Project	IEEE 802.16 Broadband Wireless Access Working Group < http://ieee802.org/16 >	
Title	Subscriber Mode Management	
Date Submitted	2005-07-11	
Source(s)	Yun Won Chung, PhD Jee Hyeon Na, Sang Ho Lee, PhD ETRI, 161, Gajeong-dong, Yuseong-gu, Daejeon, 305-700, Korea	yun.chung@etri.re.kr jhna@etri.re.kr leesh@etri.re.kr Voice: +82-42-860-5244 Fax: +82-42-861-1966
Re:	Call for Comment on P802.16g Baseline Document	
Abstract	This contribution proposes subscriber mode management.	
Purpose	The document should be considered during the resolution of comments on the baseline document.	
Notice	This document has been prepared to assist IEEE 802.16. It is offered as a basis for discussion and is not binding on the contributing individual(s) or organization(s). The material in this document is subject to change in form and content after further study. The contributor(s) reserve(s) the right to add, amend or withdraw material contained herein.

Subscriber Mode Management

Proposed Text Changes

Fig. 3 - Subscriber Mode transition diagram at MSS and BS

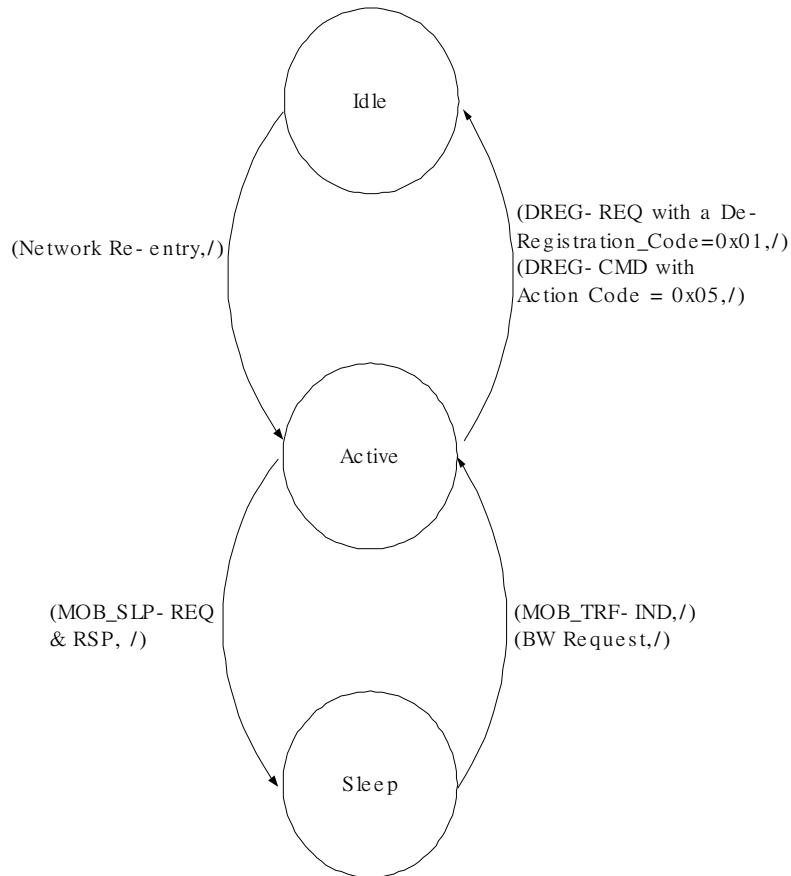
[Modify section 14.5.7 as follow]

Figure 3 shows Subscriber Mode transition diagram at both an MSS and a BS. Subscriber Mode at both an MSS and a BS changes from Active Mode to Idle Mode when the MSS issues an MSS De-registration Request (DREG-REQ) message with `De-Registration_Request_Code=0x01` or the BS issues an De-register Command (DREG-CMD) message with `Action Code = 0x05`. Then, the MSS stays at Idle Mode and updates its location when the paging group changes. The Subscriber Mode returns back to Active Mode from Idle Mode after completing Network re-entry. Transition from Active Mode to Sleep Mode is performed after an MSS successfully exchanges Sleep Request (MOB_SLP-REQ) and Sleep Response (MOB_SLP-RSP) messages with a BS. If there is any DL traffic toward an MSS from a BS, MOB_TRF-IND is broadcast to the MSS from the BS and Subscriber Mode of the MSS and the BS changes from Sleep Mode to Active Mode. If there is any UL traffic from an MSS, Bandwidth Request (BW Request) is sent to the serving BS from the MSS and Subscriber Mode of the MSS and the BS changes from Sleep Mode to Active Mode, too.

Fig. 4 - Subscriber Mode transition diagram at NCMS

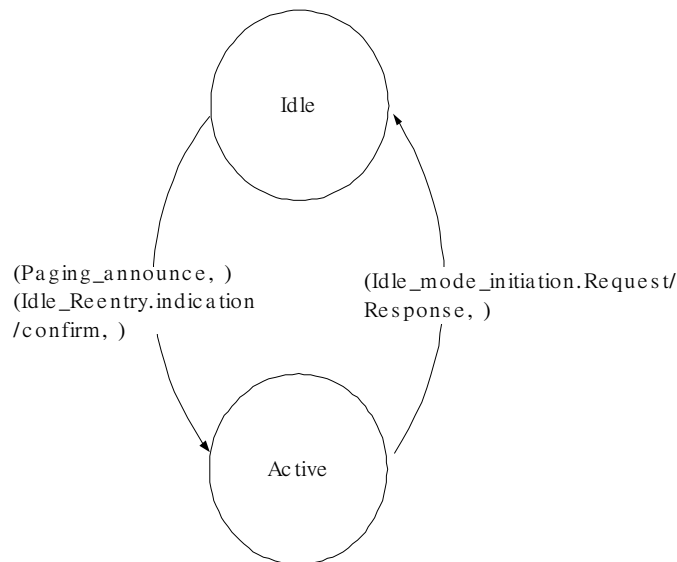
Figure 4 shows Subscriber Mode transition diagram at an NCMS with service primitives related with the Subscriber Mode transition. Subscriber Mode transition from Active Mode to Idle Mode is performed by exchanging `Idle_mode_initiation.request` and `Idle_mode_initiation.response` between a BS and an NCMS after successful DREG-REQ message with `De-Registration_Request_Code=0x01` or DREG-CMD message with `Action Code = 0x05` between an MSS and a BS, where `Idle_mode_initiation.request` and `Idle_mode_initiation.response` are defined in 14.5.11.1 and 14.5.11.2, respectively. Subscriber Mode transition from Idle Mode to Active Mode is initiated after exchanging `Paging_announce`, `Idle_ReEntry.indication`, and `Idle_ReEntry.confirmation` between a BS and an NCMS, where `Paging_announce`, `Idle_ReEntry.indication`, and `Idle_ReEntry.confirmation` are defined in 14.5.11.3, 14.5.11.4, and 14.5.11.5, respectively.
